**BRIDGE
SCOUR
EVALUATIONS**

**Queen Creek
Road Bridge
over the East
Maricopa Floodway**

Preliminary Report

**Maricopa County
Department of Transportation**

SCOUR HOLE PLOT

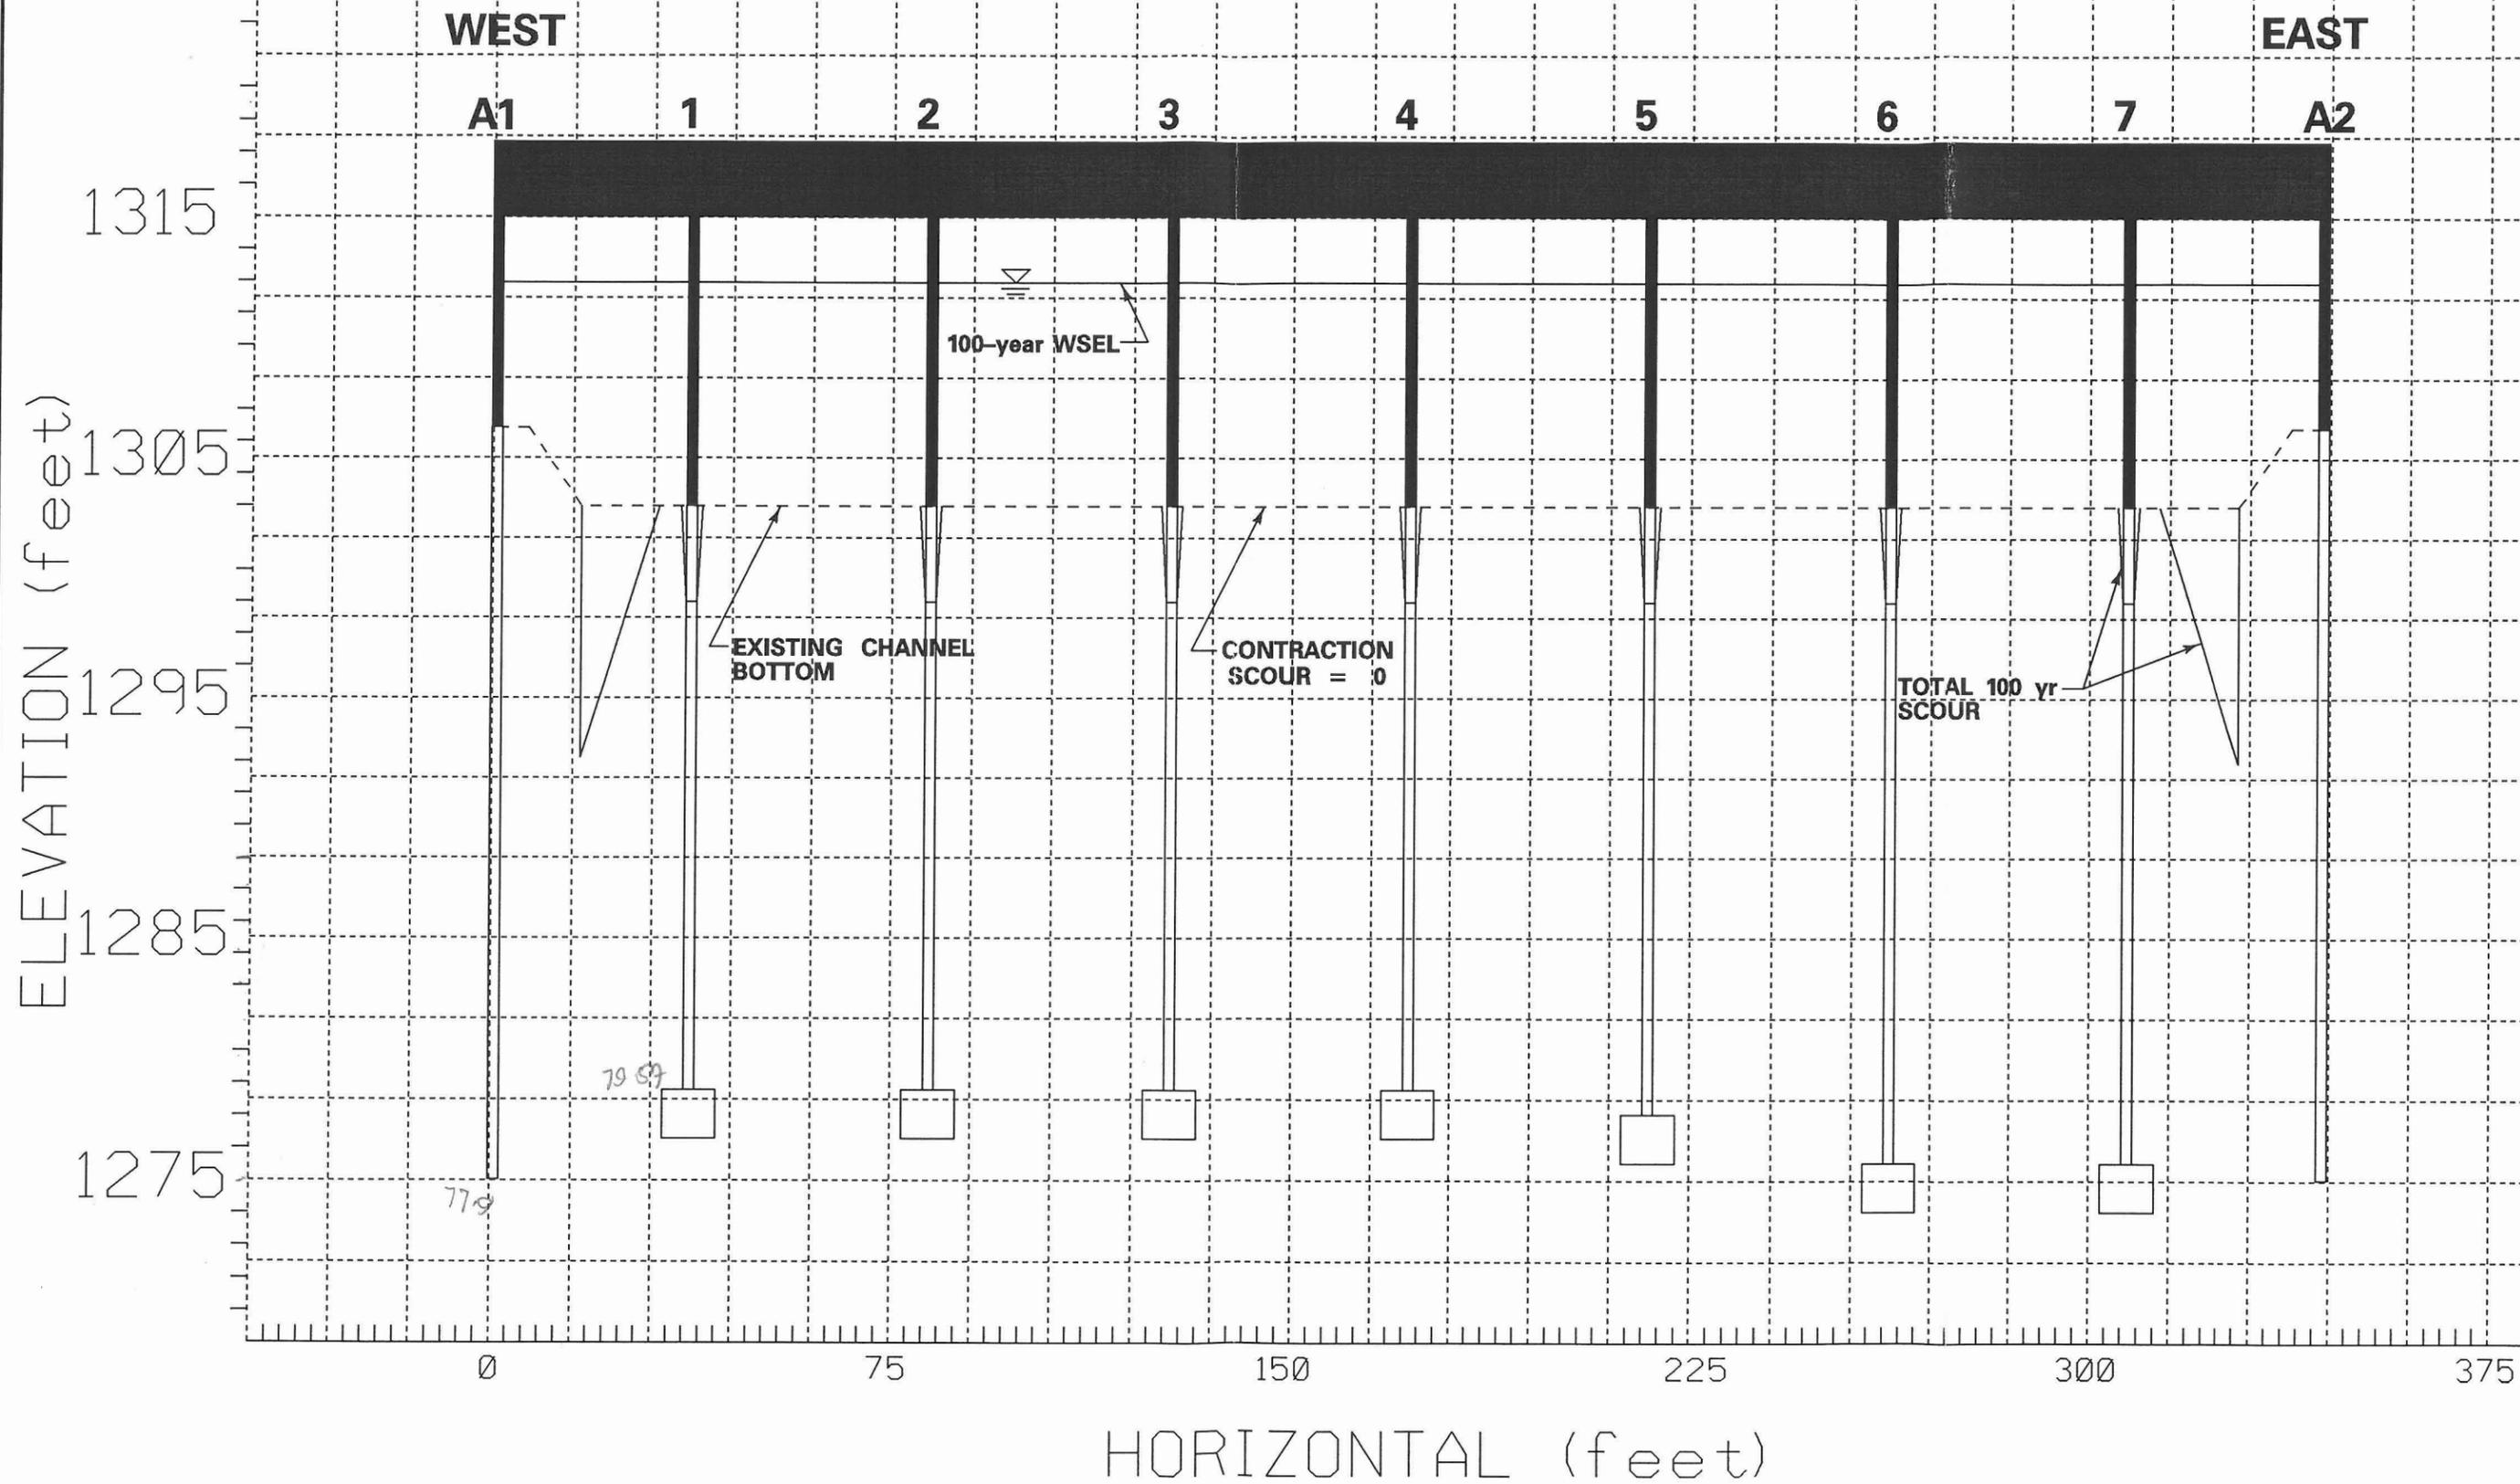
1. Need to provide HEC-2 diskett.
2. Local scour shall consider debris factor while calculating local scour (use min. 1' of debris on both side of pier.)
- 3.

add debris on both side
